Broadway-West Grand
Planning Commission, August 28, 2013
Attachment D: 6/26/13 DRC Staff
Report (with attachments)

Location:	Portion of site (Parcel B) bounded by Broadway, 23rd Street, Valley Street, and 24th Street (Parcel A is complete and occupied).
Proposal:	Amendment #3 to PUD03552 and PUDF03553 to redesign building located on Valley Street, including new site planning, decreased building height and design changes, as well as demolition of historic façade. Decreased residential density, increased commercial intensity.
Applicant:	Signature Development Group: Jamie Choy, (510)251-9270
Owner:	Signature Development Group
Planning Permits Required:	Revision to PUD, Design Review, Minor CUP for Fast Food and Auto Fee Parking, minor variance for unenclosed facility for auto-fee parking; compliance with CEQA.
General Plan:	Community Commercial
Zoning:	Community Commercial-2 Community Commercial Zone; D-BR Broadway Retail Frontage District Interim Combining Zone
Environmental Determination:	Final EIR certified on December 1, 2004 and addended in 2006 and 2008; An addendum is currently being prepared.

SUMMARY

street
elevations:
BROADWAY

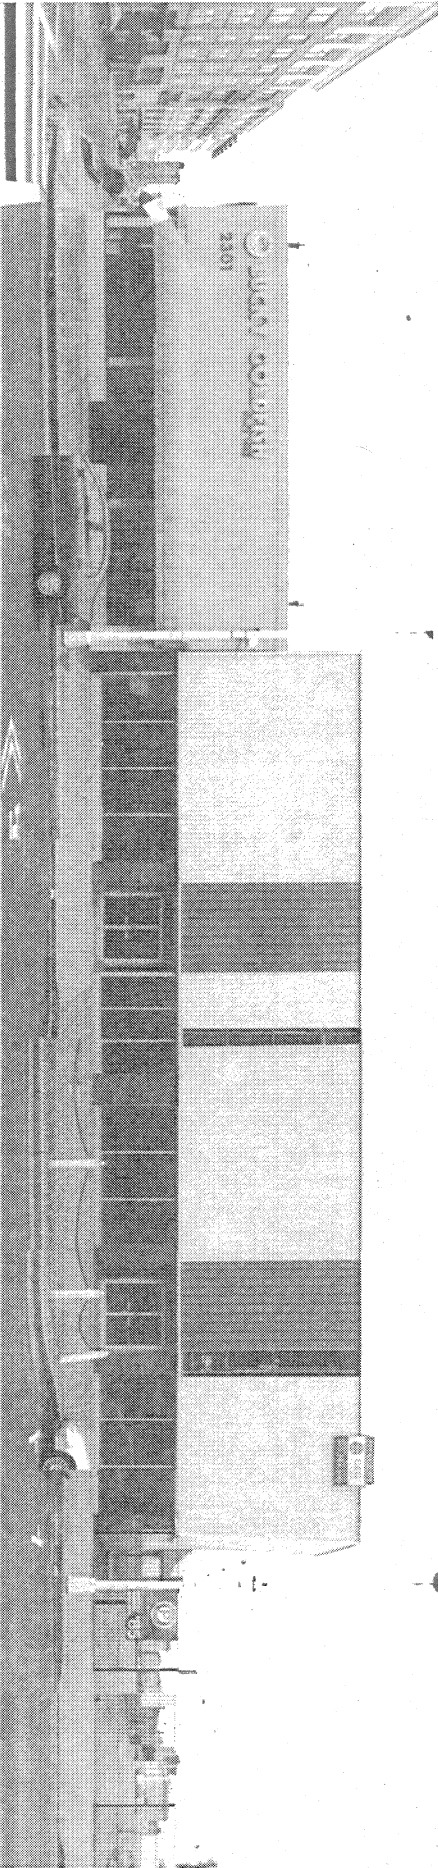
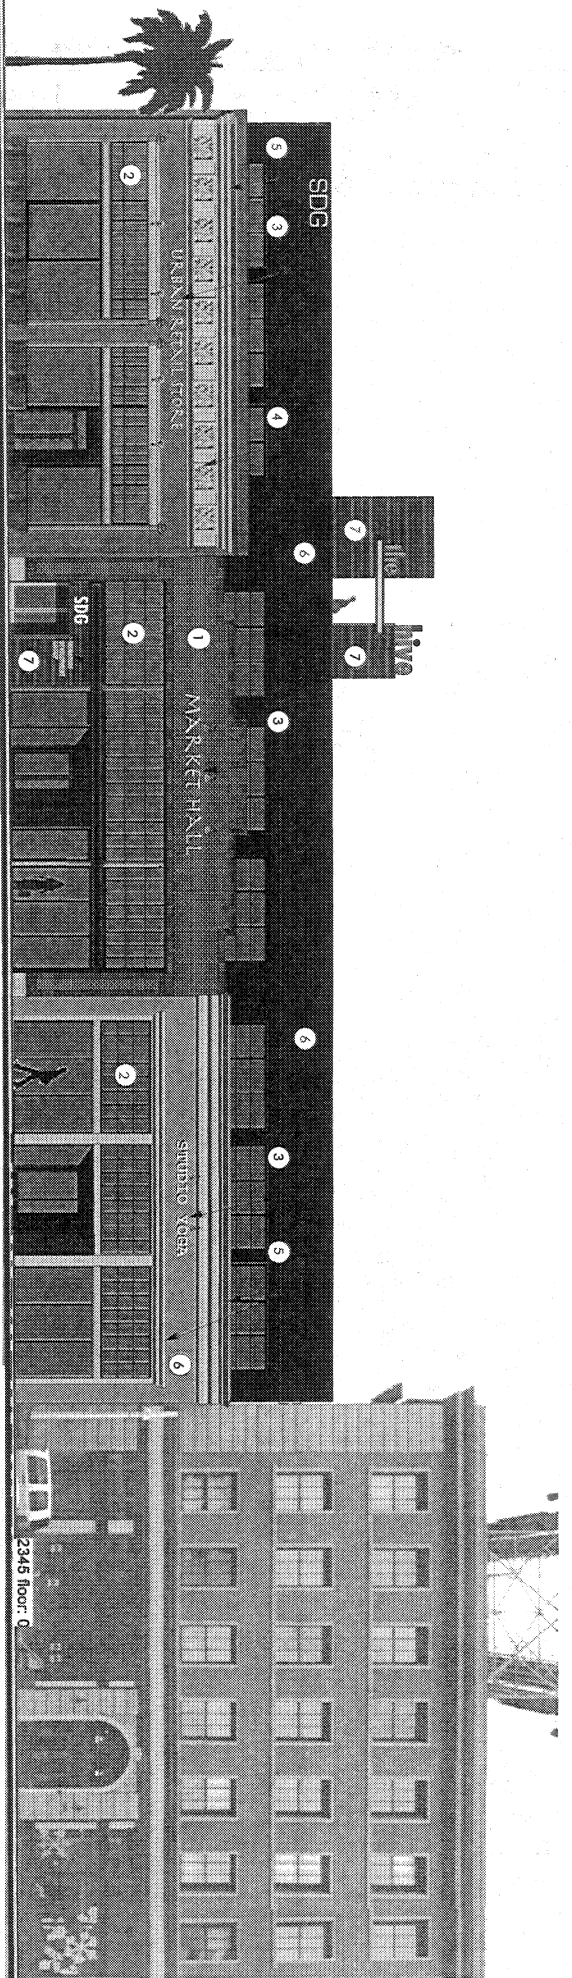
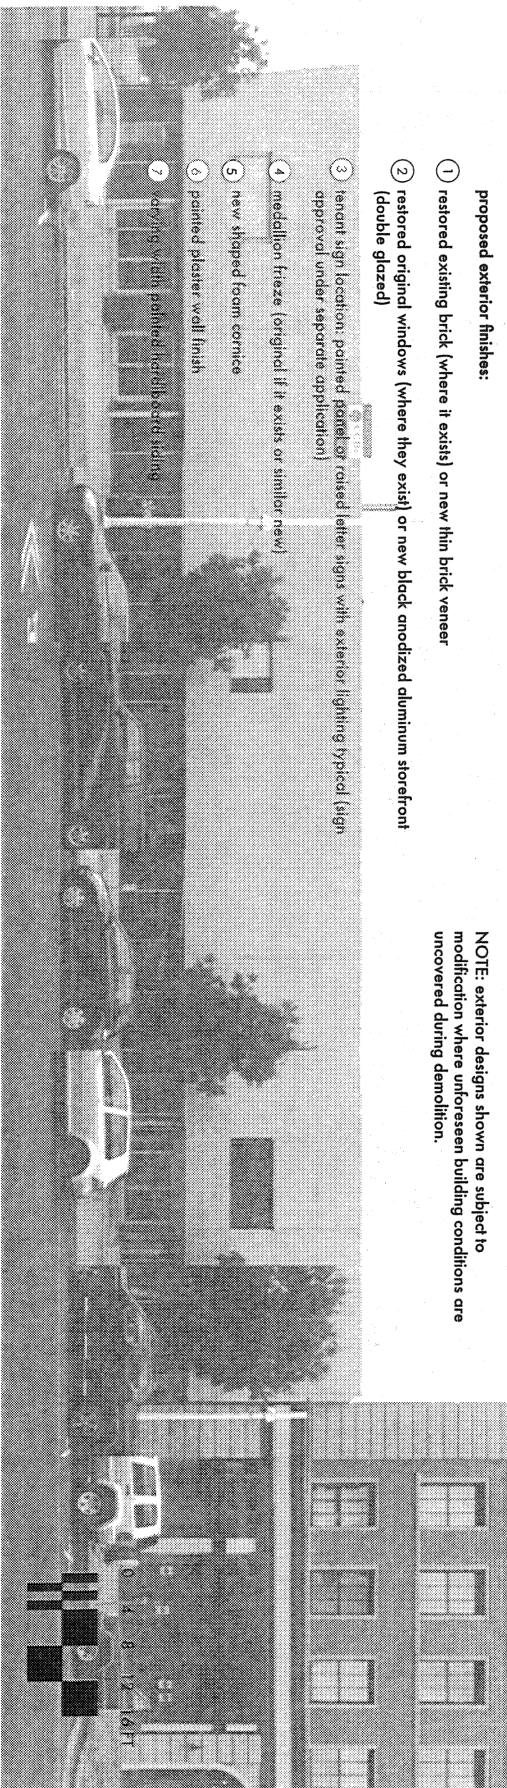
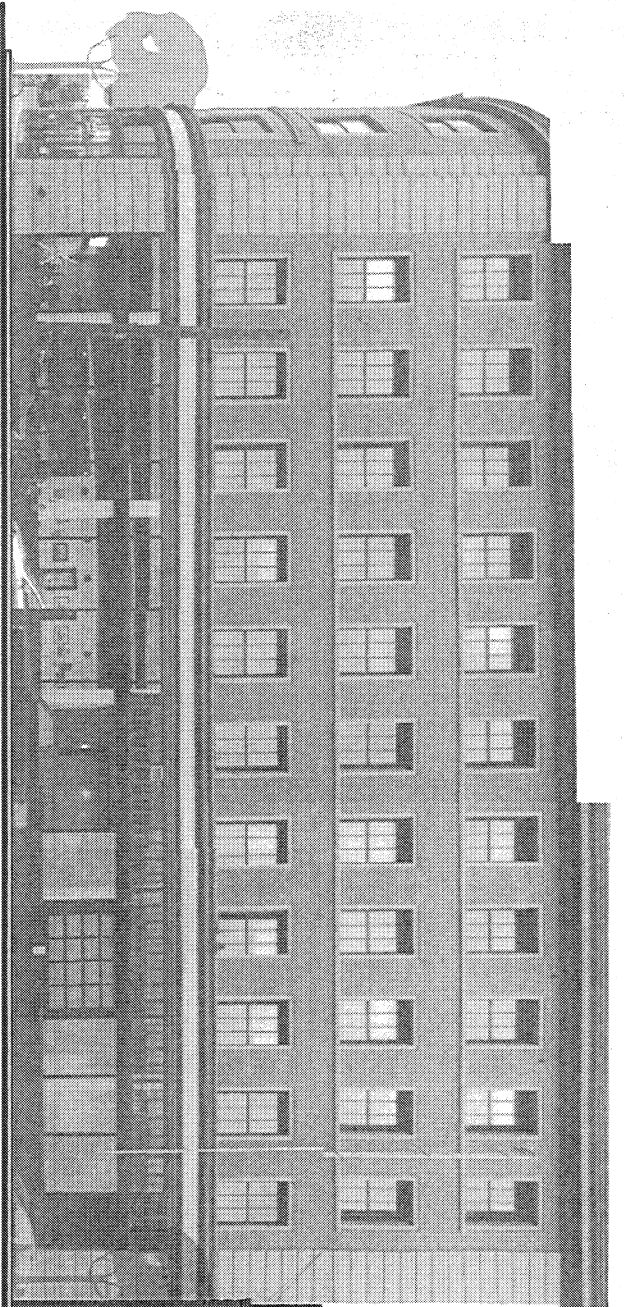
- Rehabilitation of historic facades: Staff supports the proposed renovation and rehabilitation of three historic facades along Broadway and one building on the corner of 24th and Valley Streets, consistent with the historic plans (see Attachment B).

The proposed plans include a second story addition to the three historic buildings facing Broadway. The design of the proposed second story is appropriately subtle and muted yet compatible with the historic rhythm and pattern of the historic facades. The second story is set back eight (8) feet from the front of the existing buildings.

street
elevations:
VALLEY
STREET

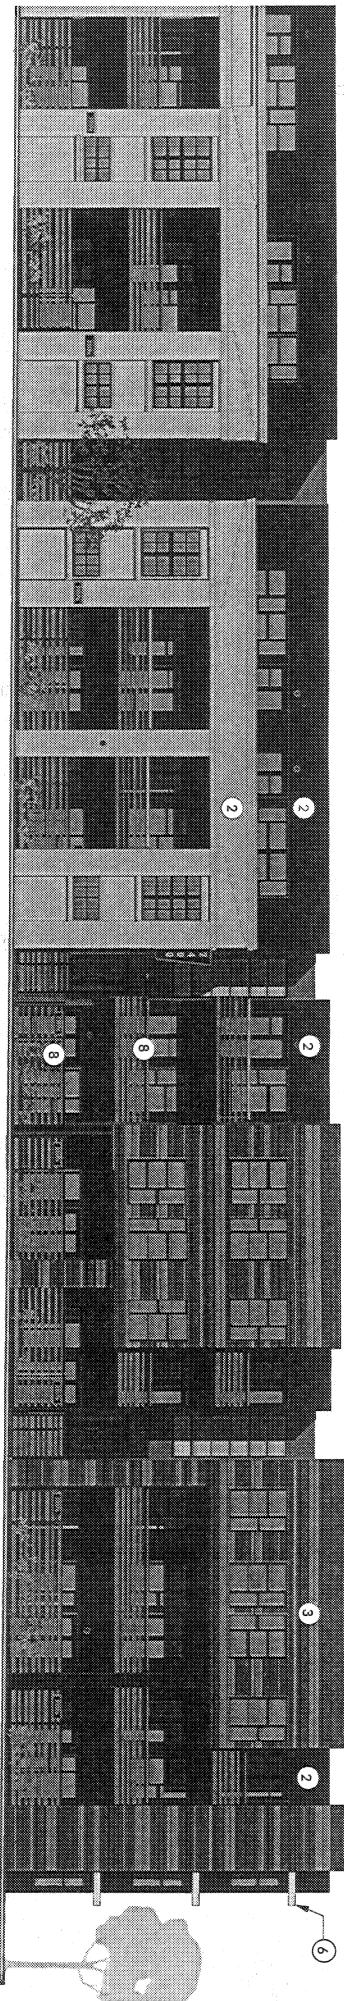
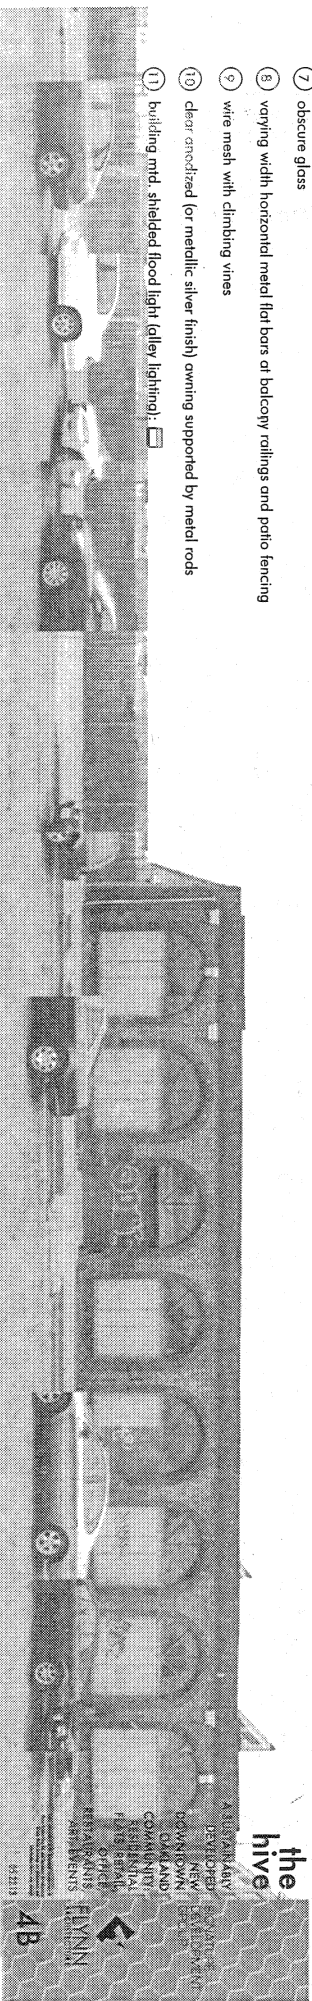
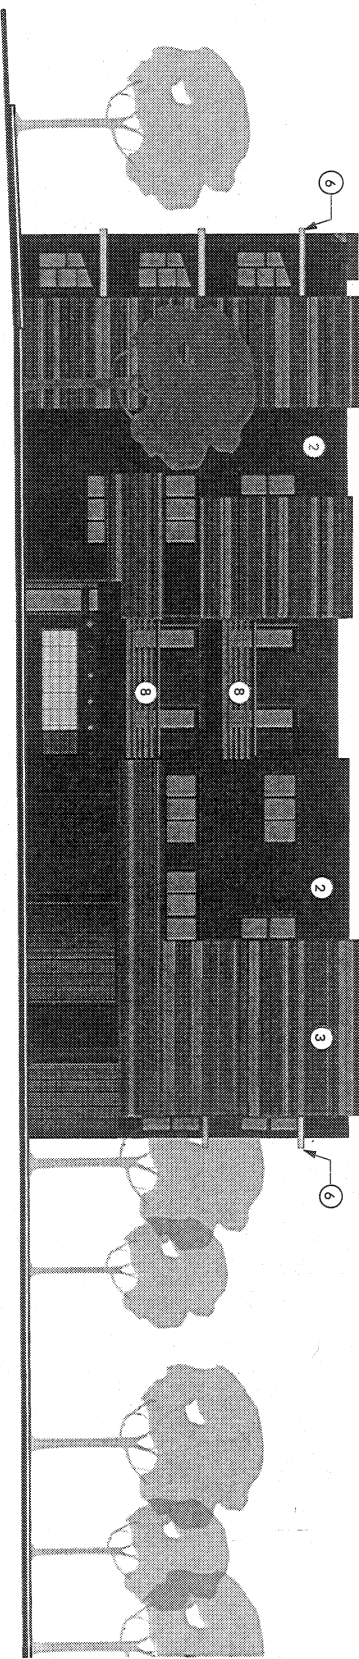
- Ground-floor patios on Valley Street: The building located on Valley Street has ground-floor units located at the front property line, contributing to “eyes on the street”. However, the at-grade patios are fenced. Staff would support designing the fencing to continue to provide a private-public barrier while also providing the appearance of openness between the public and private realms. Examples of this would include lowering the height of the fencing or raising the height of the ground-floor to three feet above grade. In addition, the horizontal fencing on the ground floor, while attractive, may be problematic from a crime deterrent standpoint (i.e., footholds for climbing).

street
elevations:
23RD
STREET

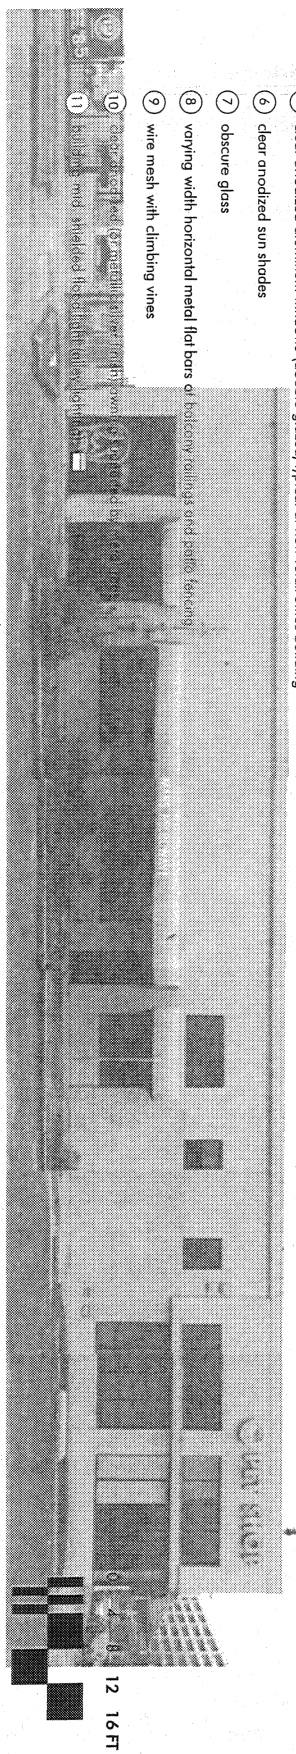
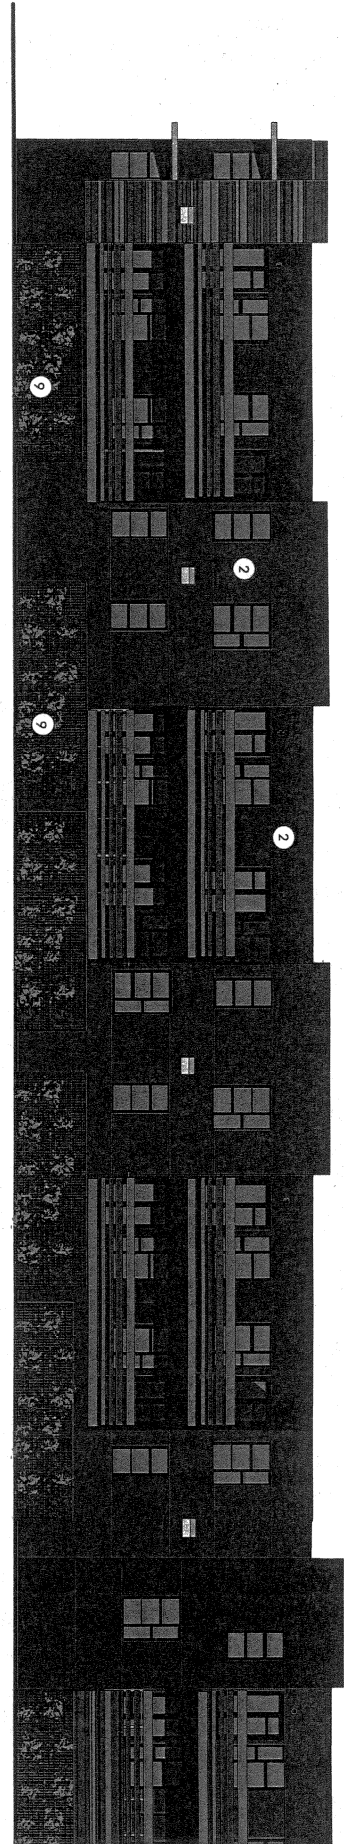
- 23rd/Valley Streets corner: The corner of the building located at 23rd and Valley Streets does not include many openings and does not provide ample transparency at this corner location. Although the design of the corner has improved since the original submittal, it could be improved to be more of a beacon of the project and to provide increased interface with the public realm. Examples include vertical projections such as towers, bays and other projecting features, and extensive glazing. In addition, staff proposes incorporating references to the historic auto-repair use at that location (without mimicry). References could be in the form of artifacts or art incorporated into the project at this location that provide whimsy and enlightenment for passers-by.

- 23rd Street façade: The 23rd Street façade, which fronts residential and parking uses, is mostly blank at the ground floor. The ground-floor frontage should provide more transparency and be softened to provide an appealing experience from the adjacent sidewalk.
